STAFF RECOMMENDATION
105 Lindsley Park Drive
February 20, 2013

Application: Demolition-contributing building and New construction-infill
District: Lockeland Springs-East End Neighborhood Conservation Zoning Overlay
Council District: 06
Map and Parcel Number: 08309046400
Applicant: Jim Richie, Owner; Zach Provonchee, Architect
Project Lead: Sean Alexander, sean.alexander@nashville.gov

<p>Description of Project: The applicant is proposing to demolish a contributing house in order to replace it with a new building.</p> <p>Recommendation Summary: Staff recommends disapproval of the application to demolish the contributing building at 105 Lindsley Park Drive as demolition meets section IV.B.1.a. for inappropriate demolition. Staff recommends disapproval of new construction since new construction will require the demolition of the existing building which is inappropriate.</p>	<p>Attachments A: Sanborn Map B: Photographs C: Site Plan D: Elevations</p>
---	--

PAINTED WOOD COLUMNS
ON MASONRY BASE

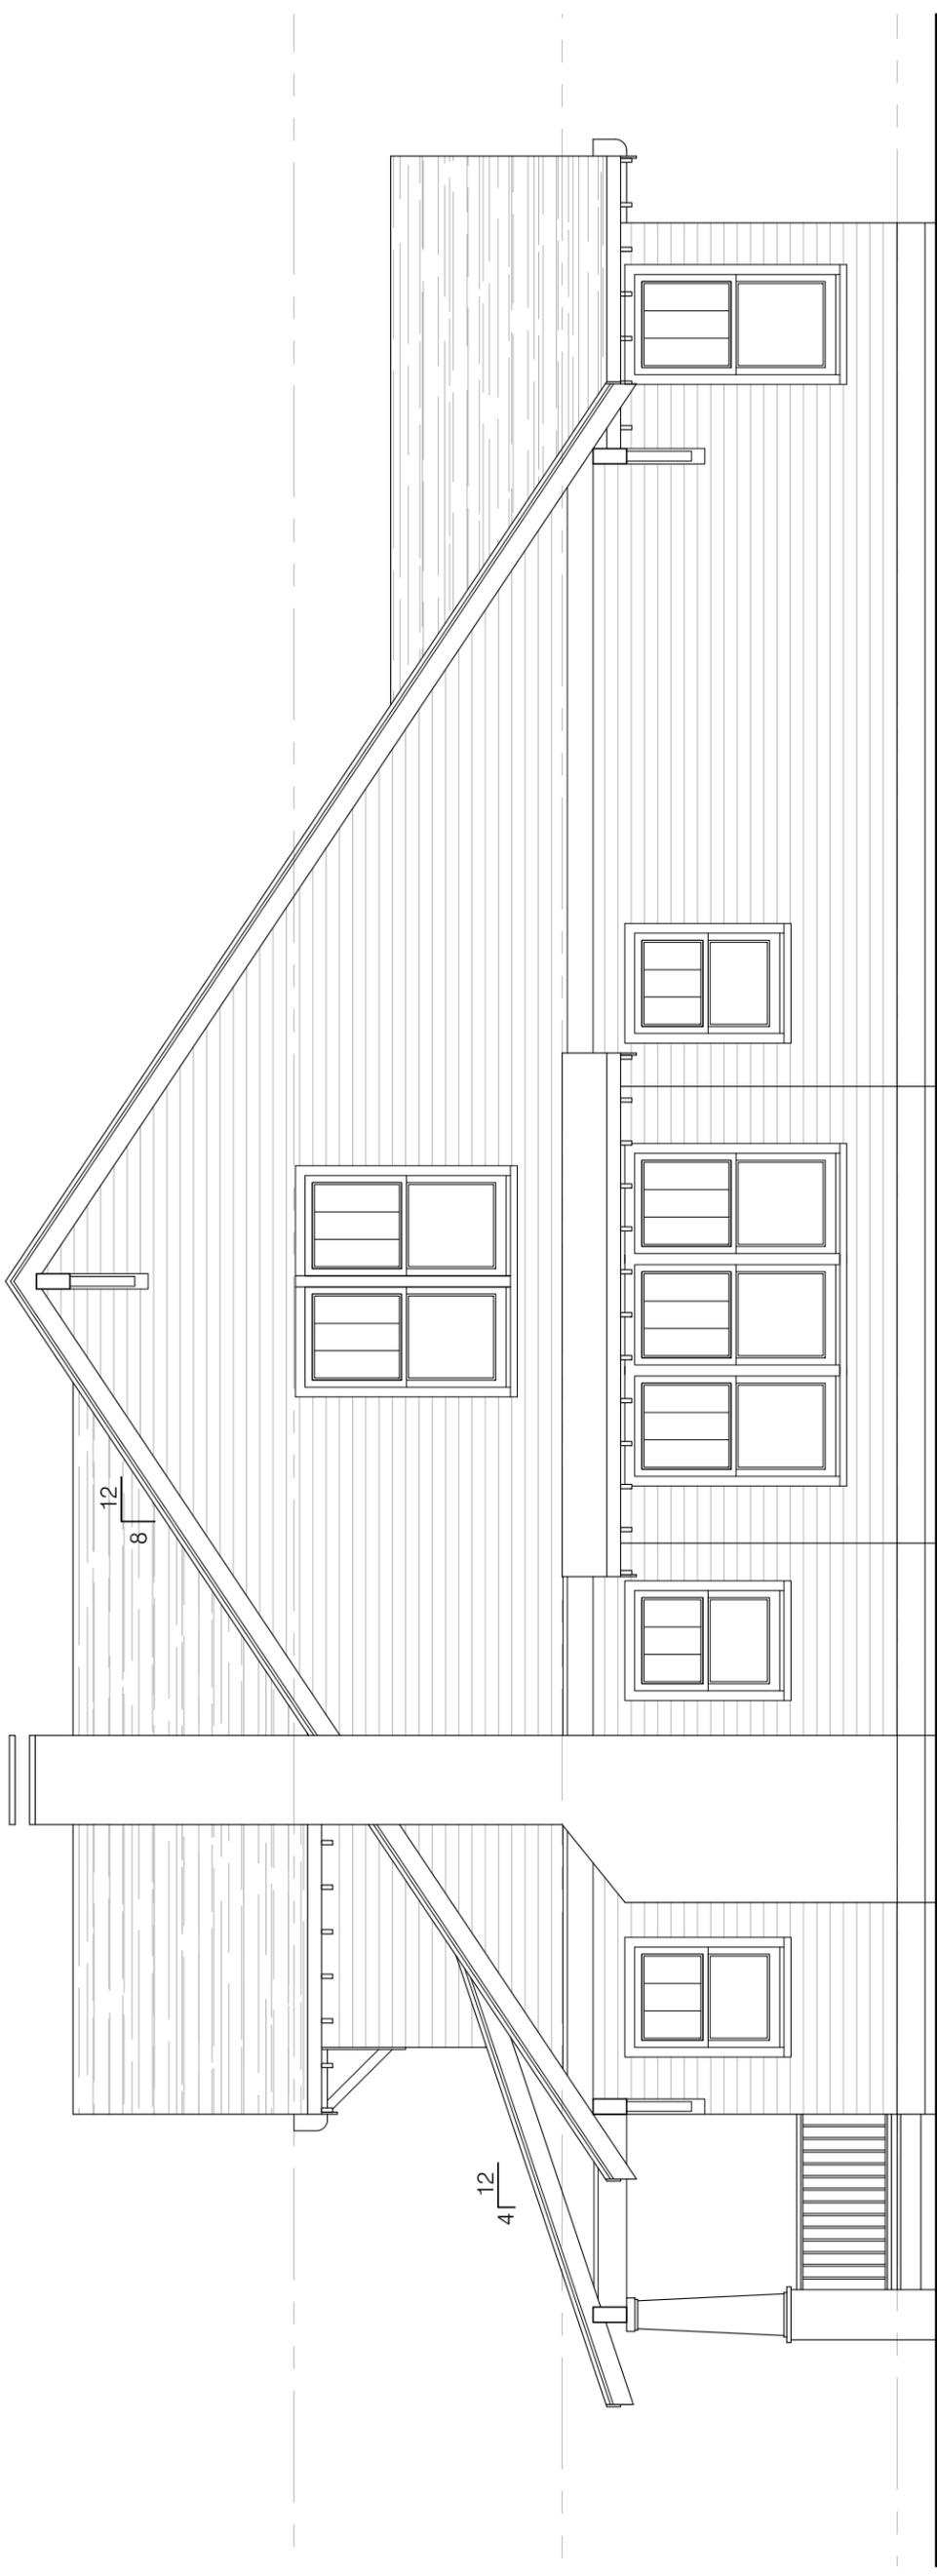
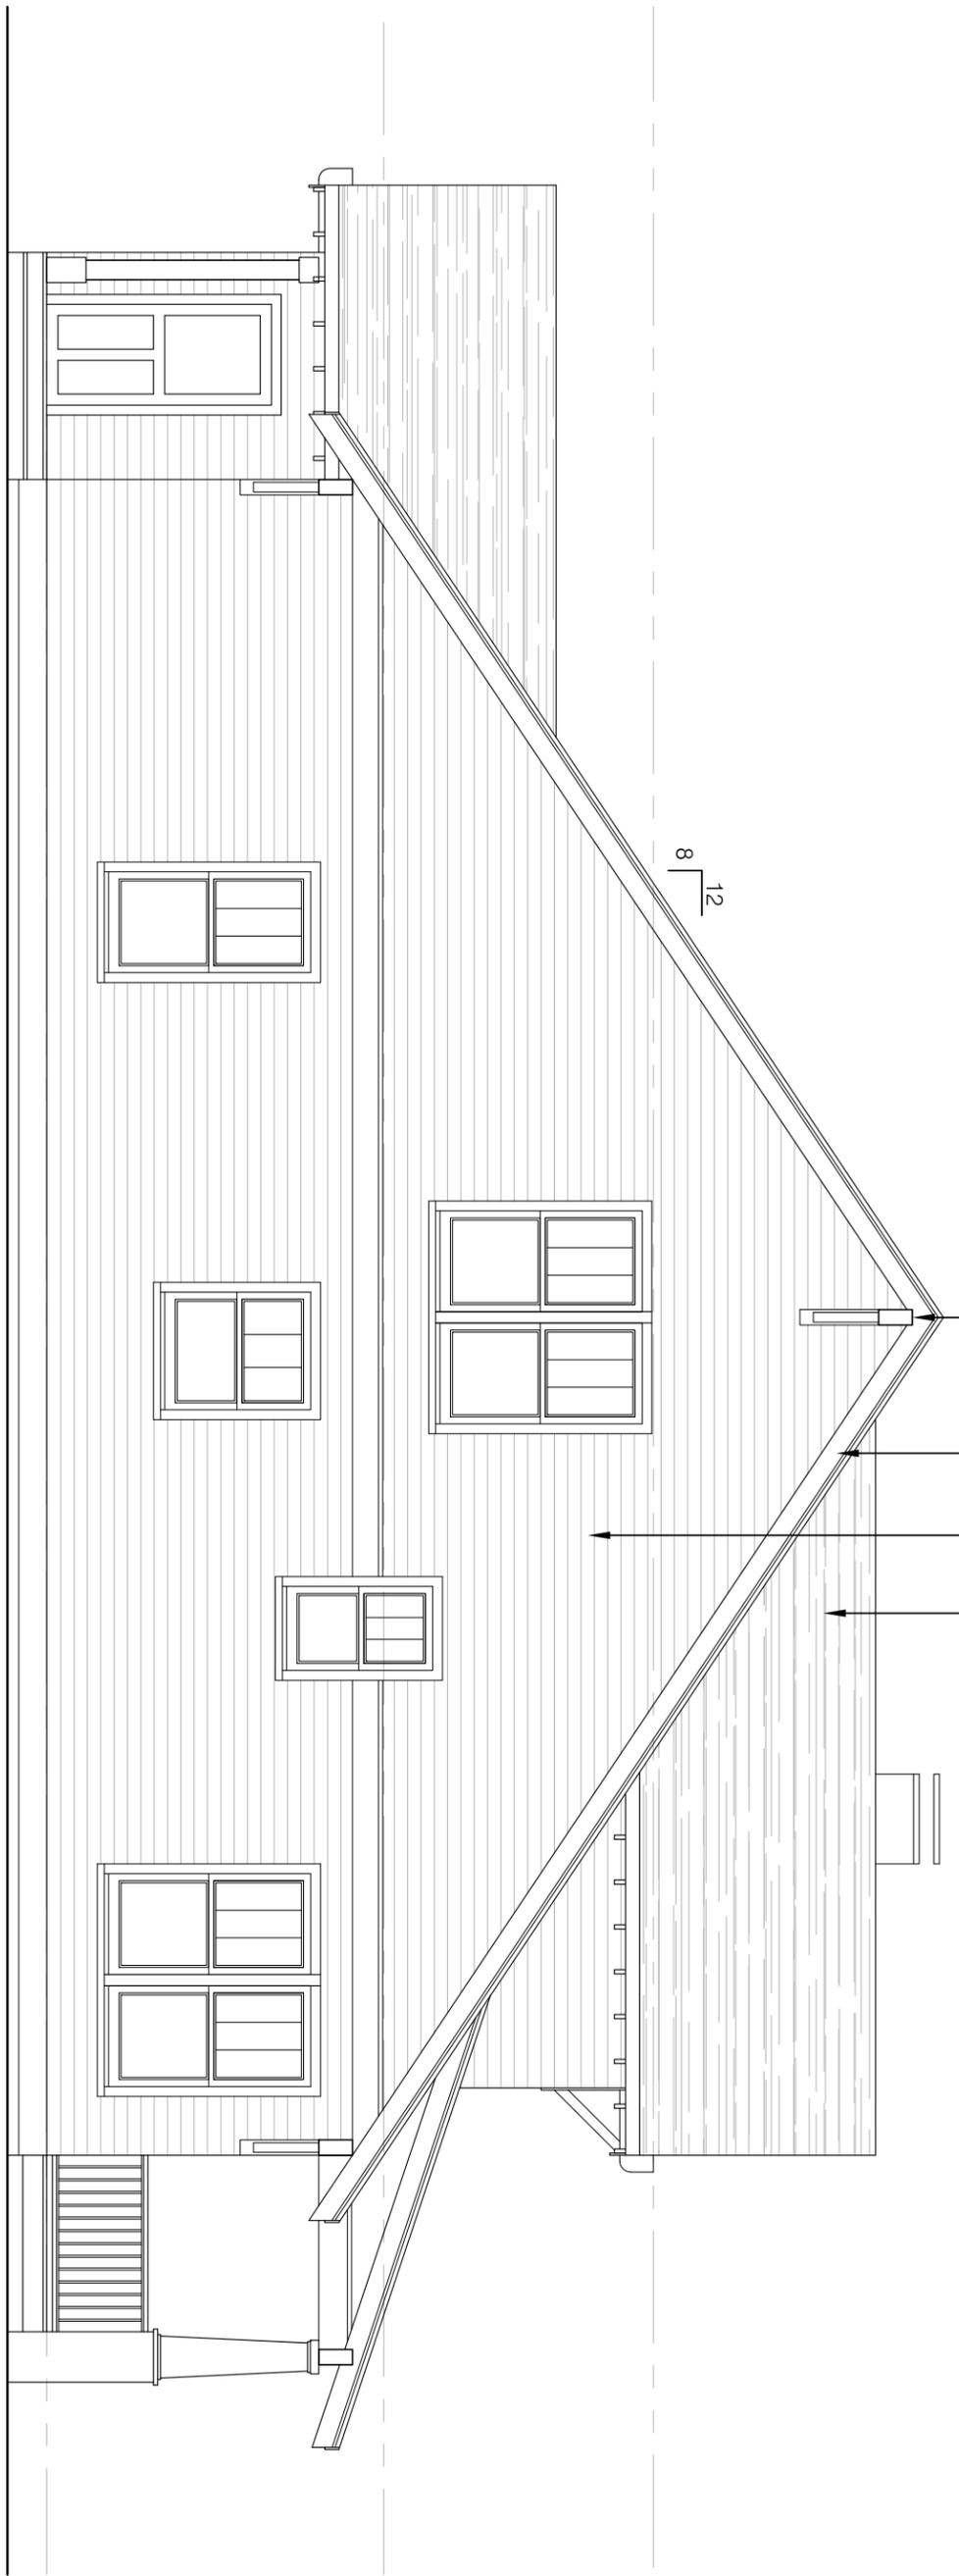
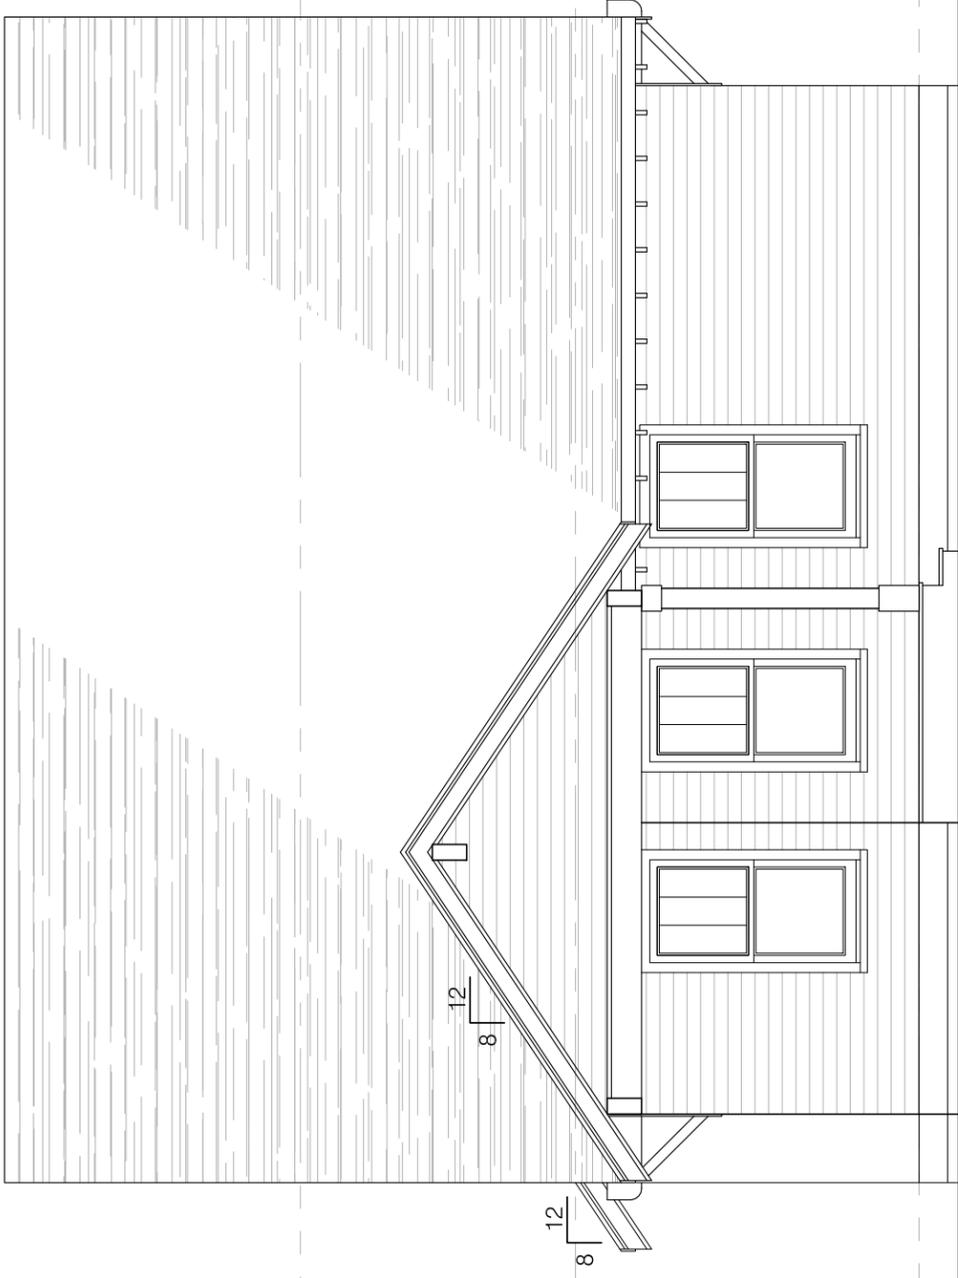
Plans for subsequent new construction were submitted by the applicant. New construction is inappropriate since it will require the demolition of a contributing structure that does not meet the ordinance's requirements for demolition. Staff recommends disapproval of new construction.
